REMARKS

The Office Action mailed October 18, 2006 has been received and the Examiner's comments carefully reviewed. Claims 1, 5, 10, 14, 15, 23-24, 27, 37, 44, 52-53, 57-59, 70, 73-76 have been amended. No new subject matter has been added. Claims 1, 3-5, 9-10, 13-15, 17-24, 27, 37-40, 42-47, 49-53, 55-59, 61-63, 69-76 are currently pending. Applicants respectfully submit that the pending claims are in condition for allowance.

Objection to the Drawings

FIG. 3A

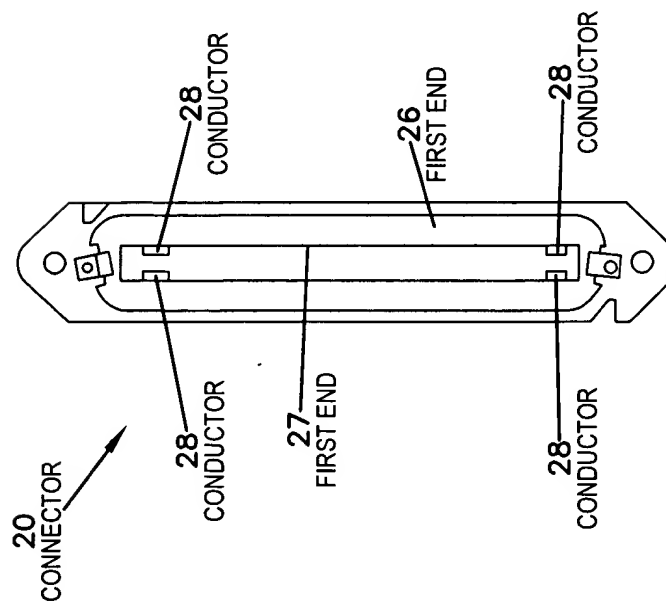
The Examiner requested the addition of legends to each of FIGS. 3A, 3B, 5C, 5D, 5E, and 6-13. Applicants have submitted herewith annotated drawings showing the addition of legends, and associated replacement sheets. Withdrawal of this objection is requested.

Legends added.
